**SEQUOYAH NUCLEAR PLANT (SQN) - UNITS 1 AND 2 - RESPONSE TO  
REQUEST FOR ADDITIONAL INFORMATION ON THE INDIVIDUAL PLANT  
EXAMINATION OF EXTERNAL EVENTS (IPEEE) (TAC NOS. M83674 and  
M83675)**

**RESPONSE TO SUPPLEMENTAL REQUEST FOR ADDITIONAL INFORMATION  
SEQUOYAH NUCLEAR PLANT (SQN) IPEEE SUBMITTAL**

Figure 3.1.3-12: Comparison of CR-0098 Rock Target Mean + one Standard Deviation Spectra to that generated for the 30 Time Histories: Sequoyah Nuclear Power Station, Component 2

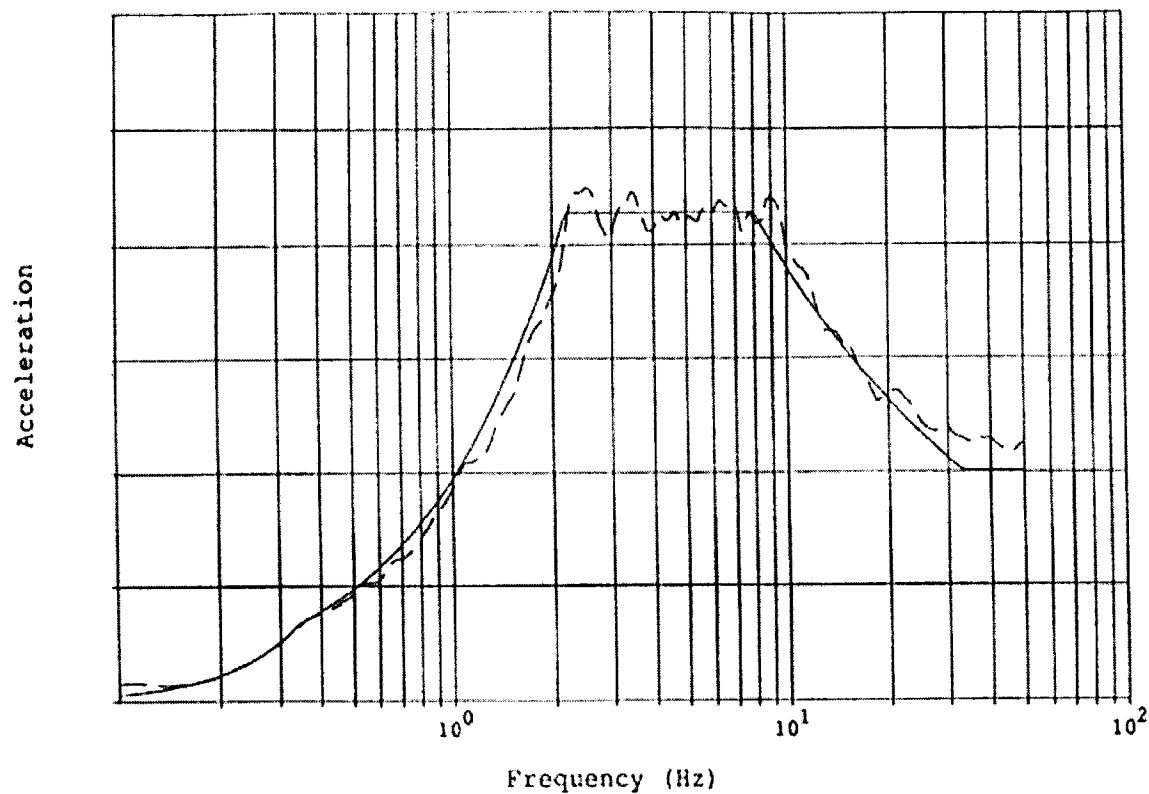
Additional studies found in SQN IPEEE Calculation SCG-5M-0004, "Top of Soil Response Spectra at the Auxiliary Control Building Location" showed that further time history scaling was needed to provide 84<sup>th</sup> percentile nonexceedance probability (NEP) responses at top of soil in the vicinity of the Auxiliary Control Building (ACB). The final scaling of the three ensembles yielded 84<sup>th</sup> percentile NEP values of PGA for Components 1, 2, and 3 (i.e., Directions 1, 2, and 3) of approximately 0.22g, 0.235g, and 0.23g, respectively, rather than the target anchor value of 0.19g.

This conservatism in the PGA level in the ensemble time histories is qualitatively illustrated in Figure 3.1.3-12 (copy attached) of the IPEEE submittal. Therefore, the most appropriate factor for converting the HCLPF values presented in the IPEEE submittal to comparable values for an RLE anchored to 0.30g at rock would be the average PGA for the three components; or a conversion factor of 1.33.

Figure 1  
Comparison of NUREG/CR-0098 RLEs anchored to 0.19g and 0.30g  
at Rock to the Sequoyah Licensing Basis Housner Spectrum

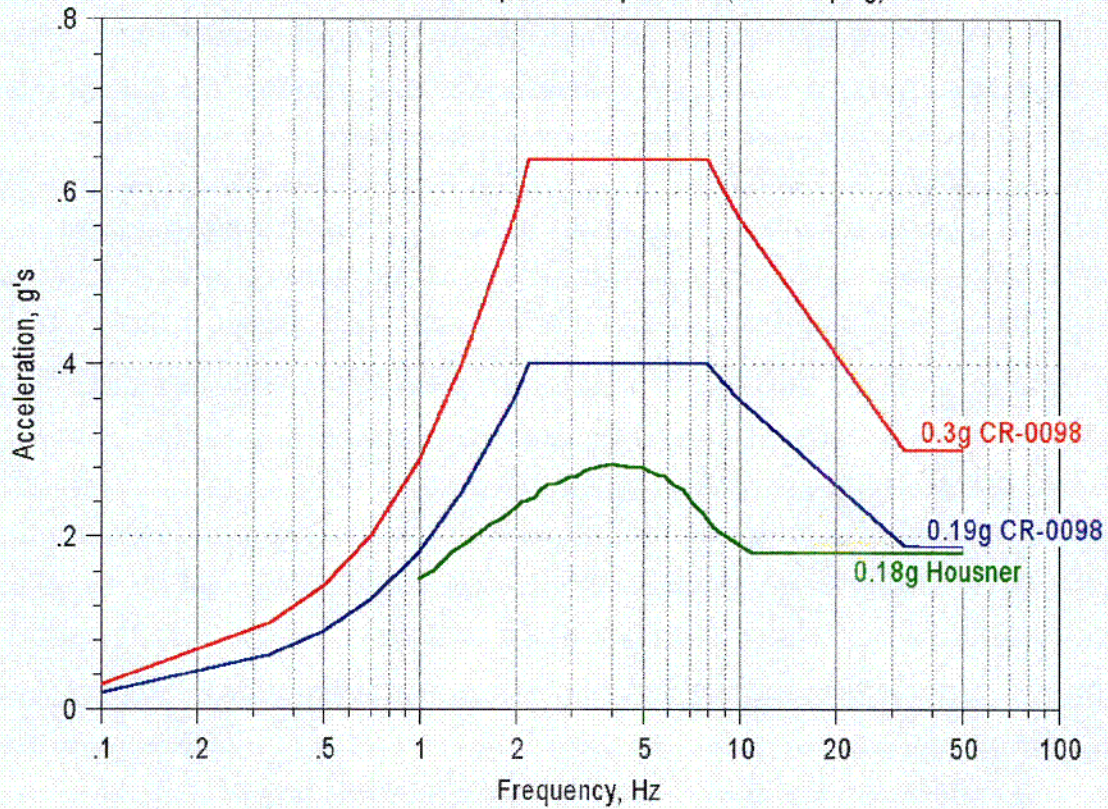
In the SQN IPEEE, the review level earthquake (RLE) was characterized in a manner inconsistent with the intent of NUREG-1407. The intent of NUREG-1407 is that the RLE control motion for SQN (which is predominantly a rock site) should be specified at rock outcrop as the NUREG/CR-0098 median 5% damped spectral shape for rock, anchored to a PGA of 0.30g at rock outcrop. The SQN IPEEE appropriately specified the RLE spectral shape as the NUREG/CR-0098 median rock spectrum at rock outcrop, but inappropriately specified the RLE PGA of 0.30g as occurring at the soil surface. Since this split approach of specifying the control motion has resulted in a rock outcrop peak ground acceleration (PGA) of about 0.19g, rather than 0.30g, the RLE seismic demands may have been considerably underestimated. The correct RLE demands may potentially be a factor of 1.58 (i.e., the ratio of 0.30 to 0.19) times those determined in the SQN IPEEE. [Stated differently, actual component capacities may be only about 0.63 (i.e., the ratio of 0.19 to 0.30) times the capacities computed in the SQN IPEEE.] Hence, components having computed high confidence of low probability of failure (HCLPF) capacities as high as 0.47g in the SQN IPEEE may have actual HCLPF capacities less than 0.30g.

The licensing basis for the Safe Shutdown Earthquake (SSE) for SQN is defined by a Housner spectral shape anchored at rock to a PGA of  $0.18g$  horizontally and  $0.12g$  vertically. Figure 1 shows the Housner spectrum for horizontal motion plotted against NUREG/CR-0098 spectral shapes anchored to  $0.19g$  (as was used for the IPEEE submittal) and  $0.30g$  (as requested in this RAI), all for 5-percent damping. This figure demonstrates the conservatism of the component capacities computed in the IPEEE submittal and in Table 1 relative to the licensing basis Housner spectrum. The tabulation below, taken from Figure 1, shows the exceedance factors (i.e., margin) of the NUREG/CR-0098 spectral shape anchored to  $0.19g$  at rock, as used in the IPEEE submittal, relative to the Housner spectrum, especially in the critical

frequency range for assessing seismic damage potential of 2-10 Hz.

This tabulation shows that HCLPFs computed for components having fundamental frequencies in the 2-10 Hz range and for an RLE anchored at 0.19g (as in the IPEEE submittal) would have a minimum margin relative to the licensing basis of 40-percent, based on the exceedance factor of 1.4 at 4 Hz. The tabulation demonstrates conclusively that HCLPFs reported in the SQN IPEEE submittal have significant margin relative to the licensing basis Housner Spectrum.
